April 17, 2014

**Subject: Response to DEQ Comments
Annual 2013 Groundwater Monitoring and LNAPL Removal Report
Port of Portland Terminal 4 Slip 3**

HC-10

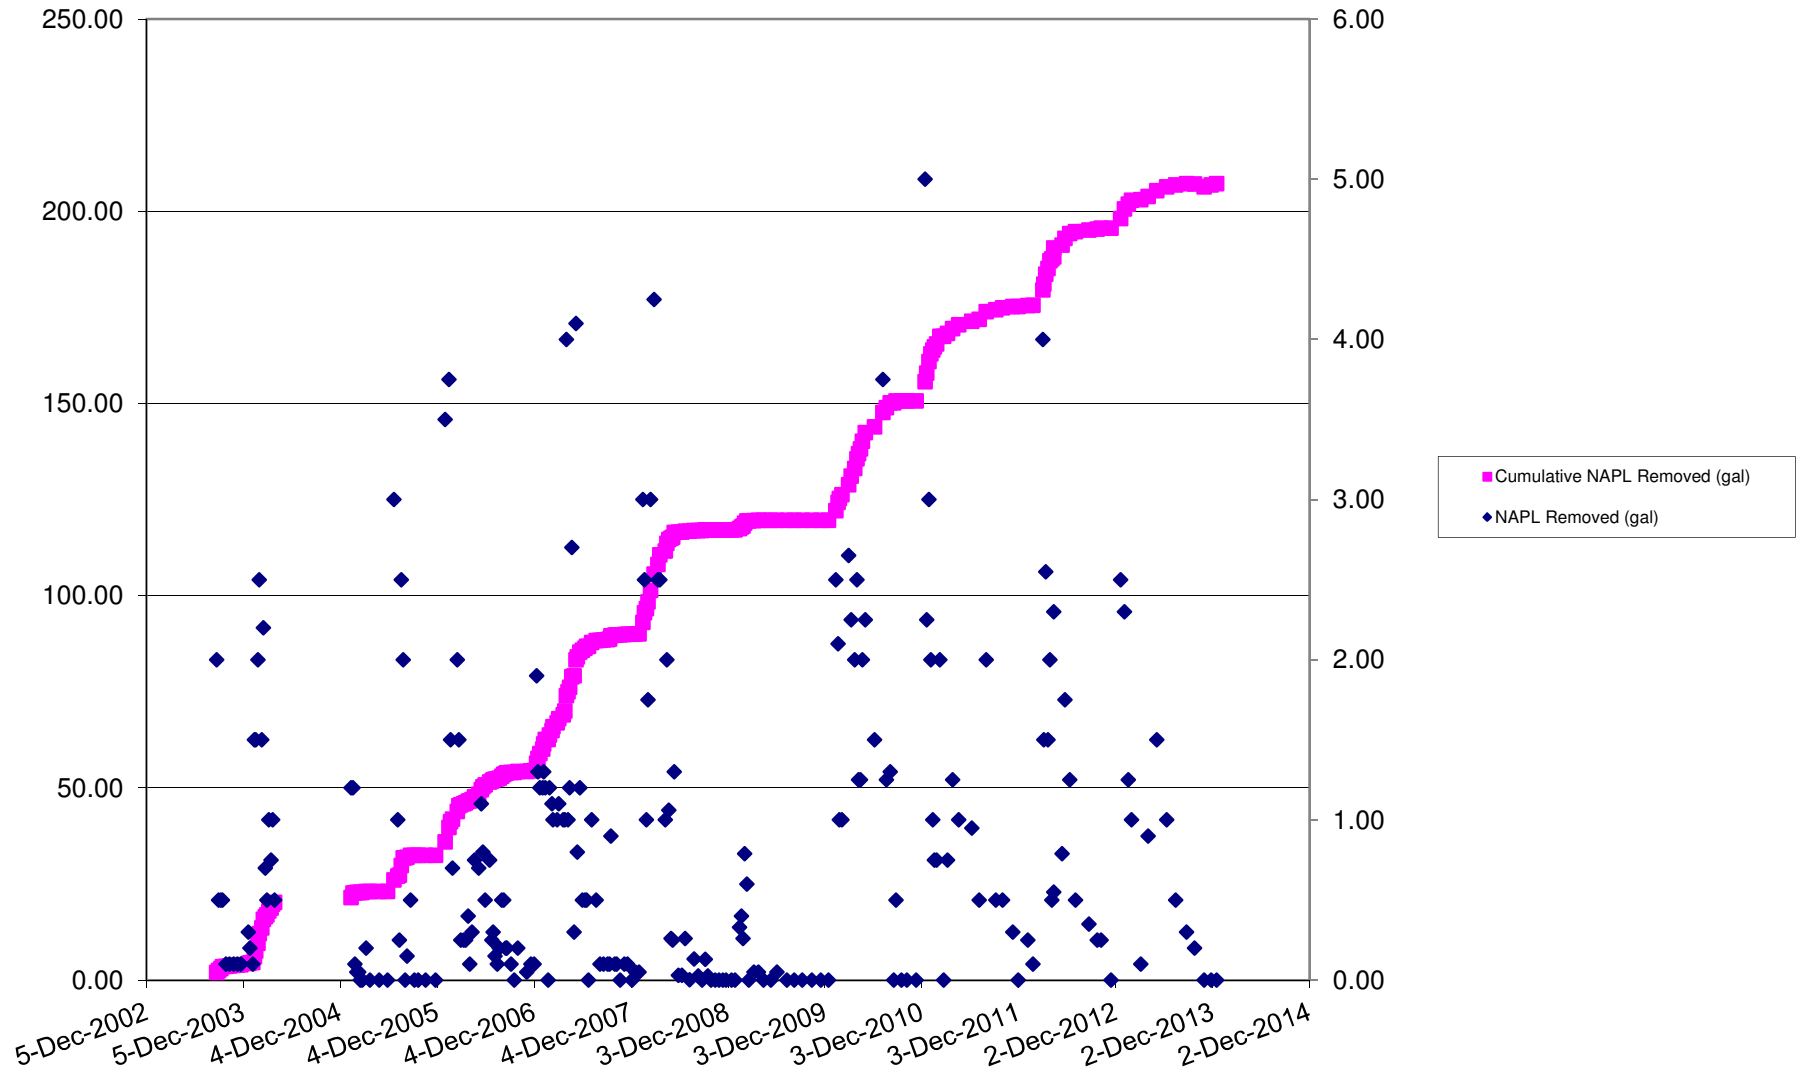
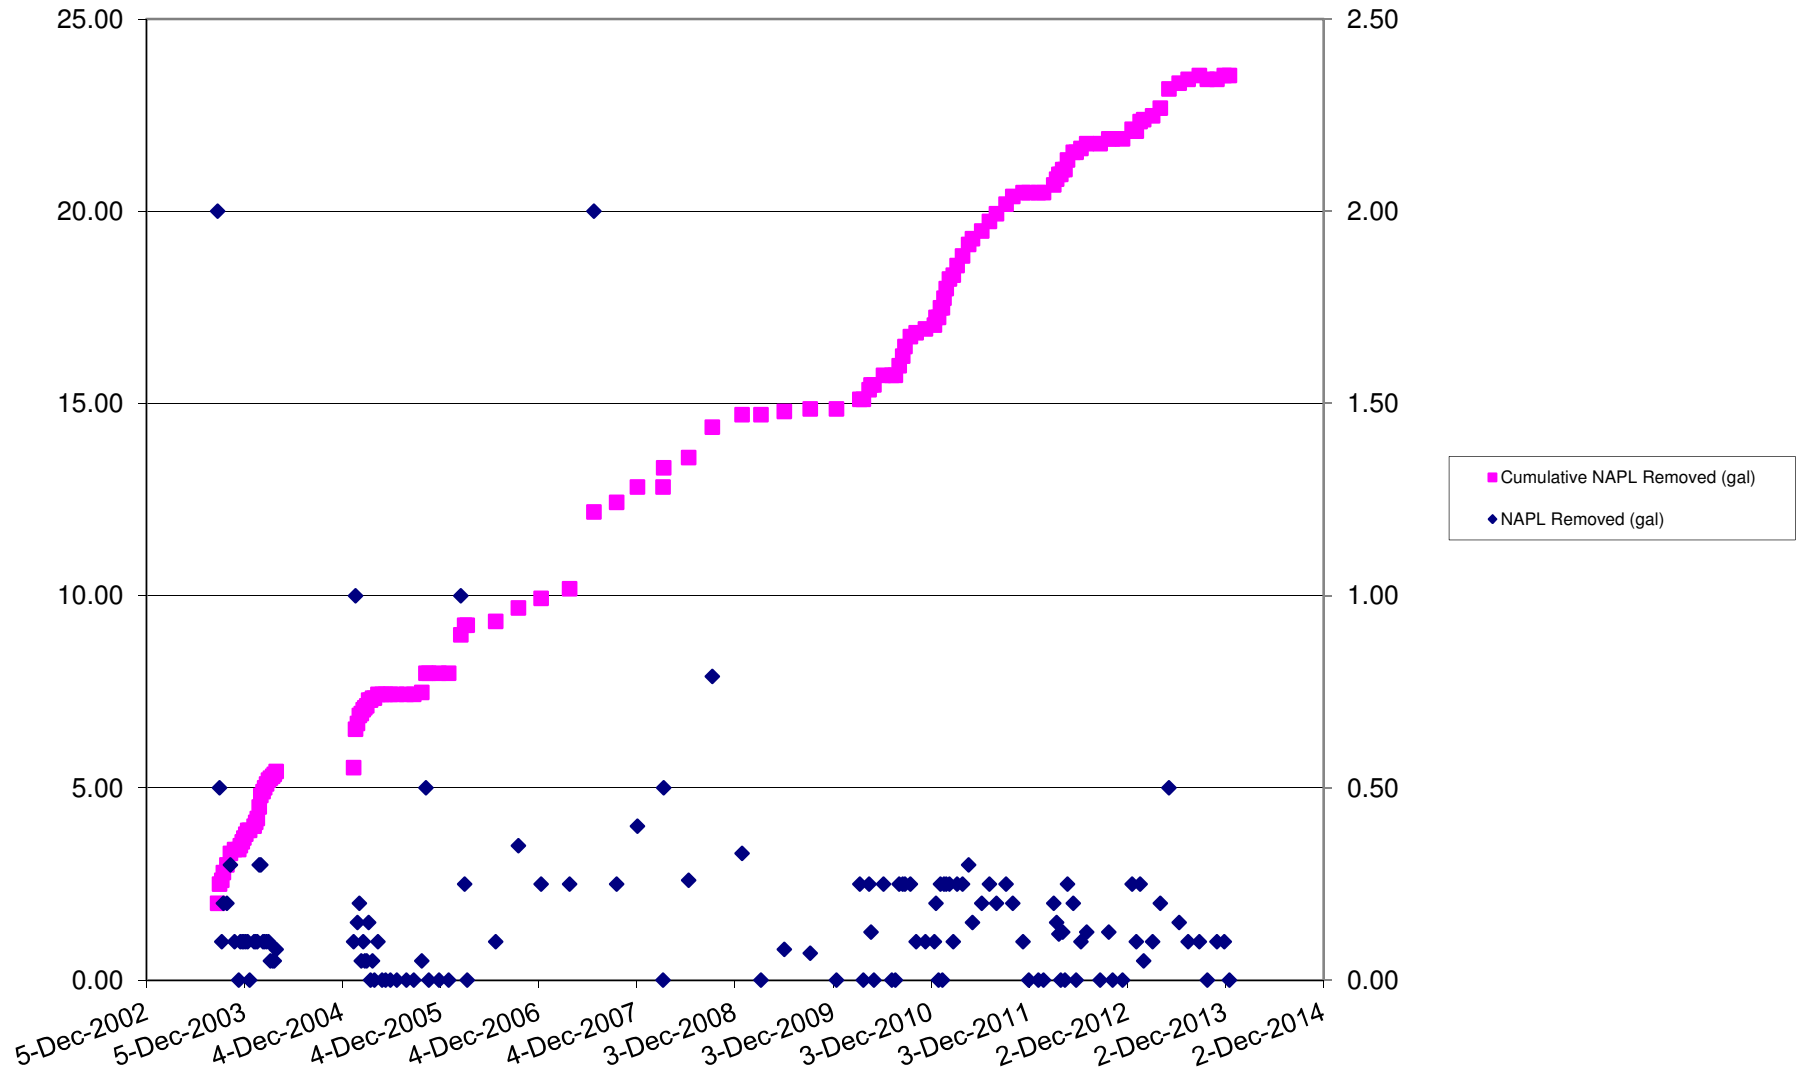
5. *Appendix C, LNAPL Thickness and Recovery Trend Plots. The scale for "NAPL Removed (gal)" on the graphs for all monitoring wells included in Appendix C should be revised so that any downward trend of recoverable NAPL can be visualized.*

Response. The plots in Appendix C have been modified to show the LNAPL removed for individual events on an expanded scale secondary y-axis.
